SUBJECT: UNIVERSITY OF MISSOURI AT COLUMBIA – STAFF ASSESSMENT OF
APPLICABILITY OF FUKUSHIMA LESSONS LEARNED TO UNIVERSITY OF
MISSOURI - COLUMBIA RESEARCH REACTOR

STAFF ASSESSMENT OF APPLICABILITY OF
FUKUSHIMA LESSONS LEARNED TO THE UNIVERSITY OF
MISSOURI AT COLUMBIA RESEARCH REACTOR
LICENSE NO. R-103; DOCKET NO. 50-186

Figure 3.2-1. Shear Wave Profile for MURR site

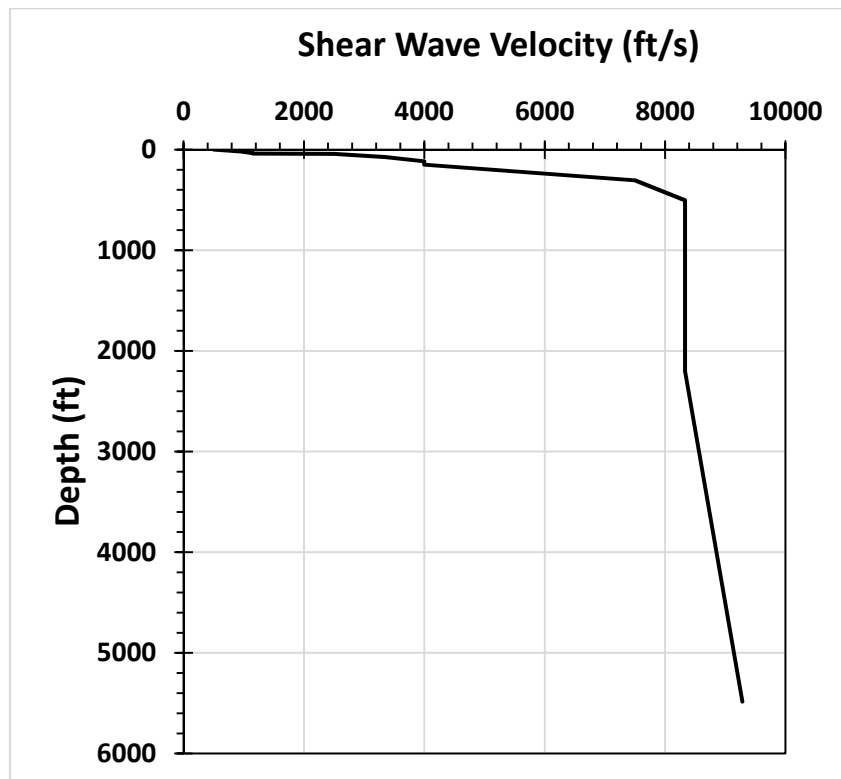
To estimate the parameters necessary to conduct the site response analysis, the NRC staff studied available information from the MURR facility and the nearby nuclear power generating facility, the Callaway Nuclear Plant. Other available information relevant to site response analysis was also studied. Several boreholes were drilled to characterize the subsurface when constructing the containment building of the MURR facility (University of Missouri, 2006). Other boreholes were drilled later for surrounding facilities. These boreholes provide qualitative description of different soil strata beneath the containment building. However, these boreholes were too shallow to encounter the general rock conditions, defined as rock strata having shear wave velocity of 2.8 km/s [9,200 ft/s] (NRC, 2007a). Moreover, no shear wave velocity measurements are available in any of the subsurface materials at the MURR site. Only a few boreholes had the Standard Penetration Test (SPT) blow count measured at a few depth intervals but information on the blow hammer used in these tests is not available. Although the NRC staff estimated the shear wave velocity from the SPT results assuming a standard blow hammer, the data are incomplete for site response analysis because these boreholes were too shallow. However, descriptions of the soil strata at the MURR site match with those at the Callaway Nuclear Plant site (Ameren Missouri, 2014). There are only minor differences between the shear wave velocity for the soil layers at the Callaway Nuclear Plant site and those estimated at the MURR site from the SPT measurements. Consequently, the NRC staff has used in the site response analysis the shear wave velocity of each soil and rock stratum of the MURR site as available from the seismic assessment of the Callaway Nuclear Plant (Ameren Missouri, 2014). Figure 3.2-1 shows the shear wave velocity profile with depth from surface developed in this assessment.

Figure 3.2-2 Mean Control Point Hazard Curves at Three Frequencies.

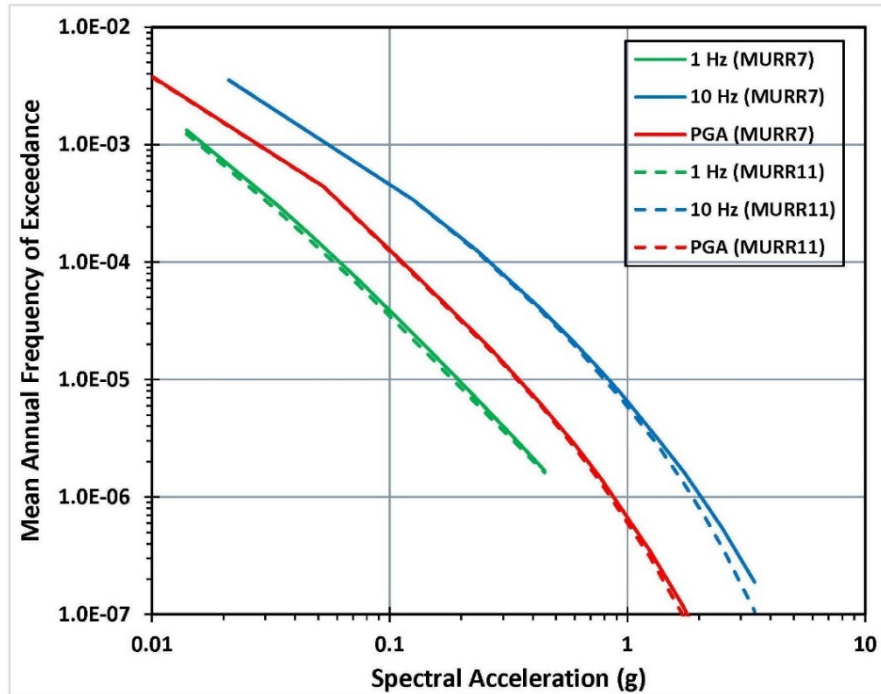
The NRC staff has estimated the seismic hazard curves at the control point; i.e., at the top of the weathered rock layer. The results are shown in Figure 3.2-2. The NRC staff has also calculated the 10^{-4} and 10^{-5} uniform hazard response spectra using the results of its confirmatory PSHA and site response analyses and then computed the GMRS following the criteria in RG 1.208 (NRC, 2007a). The results are plotted in Figure 3.2-3. The GMRS is the performance-based site-specific ground motion response spectrum.

Figure 3.2-4. Comparison of the NRC Staff's GMRS with the Design Response Spectrum for the MURR Site

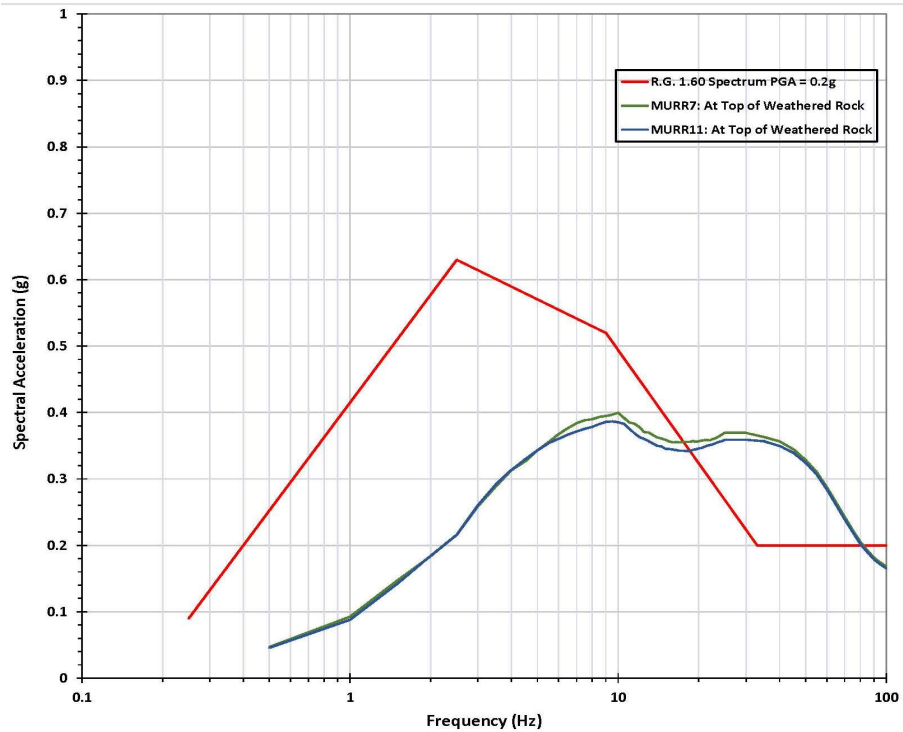
Figure 3.2-4 shows the seismic response spectrum with PGA of 0.2g, as used in the Callaway Nuclear Plant (Ameren Missouri, 2014). As discussed before, the MURR facility has adopted a similar seismic response spectrum as SSE. This figure also shows the GMRS estimated in this assessment for both options of material properties used (MURR7 and MURR11). First, there is practically no difference between these two options used for material properties on the GMRS estimated at the selected control point. Second, the GMRS is enveloped by the SSE up to about 16 Hz. The GMRS exceeds the SSE above this frequency. Based on EPRI guidance (EPRI, 2012), the ground motions at higher than approximately 10 Hz frequency are not damaging to the structures, systems, and components of a nuclear reactor except the functional performance of components sensitive to vibration, such as electrical relays. Based on the

information provided during a phone call with the University of Missouri staff on June 14, 2016, every safety feature in the MURR facility has been designed to fail in “fail safe” mode. The relays would disengage due to high frequency vibration, similar to a loss of power event, resulting in dropped control rods in the reactor. Due to passive nature of the design, no electric power is needed for safe shutdown and maintaining cooling of the reactor. Therefore, based on this information, the NRC staff concludes that no additional assessment would be needed for the higher frequency ground motion exceedance at the MURR facility.

The NRC staff assessed the seismic hazard of the MURR facility using present-day methodologies (EPRI, 2012) and RG. Based on the re-evaluated seismic hazard, the GMRS is enveloped by SSE in the 1 to 16 Hz range. Although the GMRS exceeds the SSE at frequencies larger than 16 Hz, “fail safe” failure mode of the safety features will drop the control rods in the reactor in such events. Moreover, passive design of the reactor does not require electric power for safe shutdown. Therefore, the NRC staff concludes that no additional assessments would be needed for seismic-related hazards. Additionally, no other assessments would be needed for seismic-induced sloshing and high-wind-related hazards.
